Goulburn Street School Crossing Existing Conditions Road Safety Audit

Prepared for Strathbogie Shire Council

10 September 2023

Reference J388O530/0923

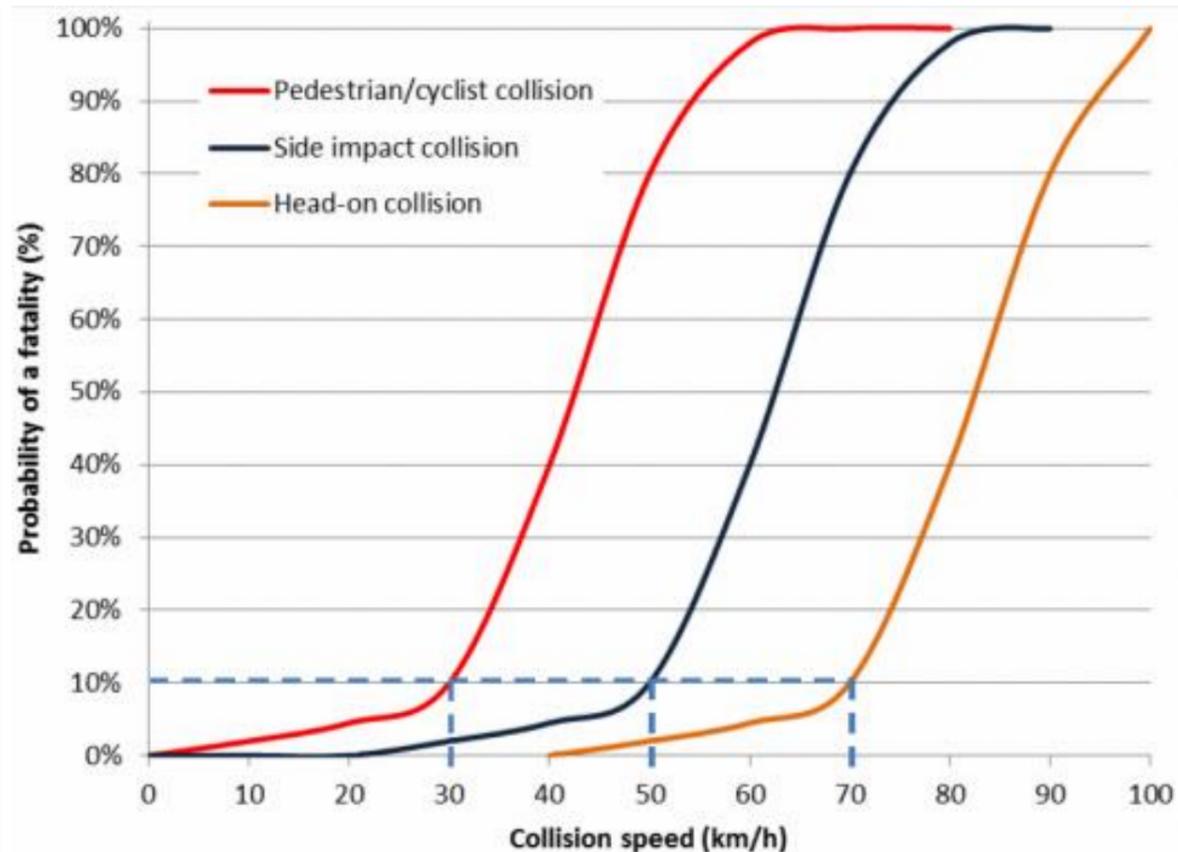
6 Presence of heavy vehicles is a vital consideration when analysing the potential of crashes and their corresponding severity. A higher mass will generate a higher kinetic energy resulting in more severe crashes than when crashing with a passenger vehicle travelling at the same speed. Presence of multiple heavy vehicle movements is generally not encouraged in locations with high pedestrian activity due to this reason and various similar reasons.

Under the Safe System Principles, it is vital to understand the risk of being killed increases steeply as the speed reaches 30km/h or more when it comes to a collision with a pedestrian. A diagram extracted from The Safe System Approach (Austroads) is provided below for reference.

It is said “the human body is vulnerable not built to withstand impact forces greater than 30km/h – any impact greater than 30km/h greatly increases the risk of dying”.

Consider reducing the speed limit to 30km/h or lower (P).
 Consider implementing LATM devices to reduce vehicular speeds (P).

Considering these factors, RedSquare Traffic recommends lowering the speed limit in accordance with the Safe System Framework, to 30km/h or less on the approach to the crossing to reduce the “severity of collisions”, should a collision is to take place. It is beneficial if such a posted speed limit is supplemented by Local Area Traffic Management (LATM) treatments that would reduce the driver speeds through speed limiting devices (e.g. road humps, rumble strips) rather than relying on drivers to comply with regulatory speed limits.
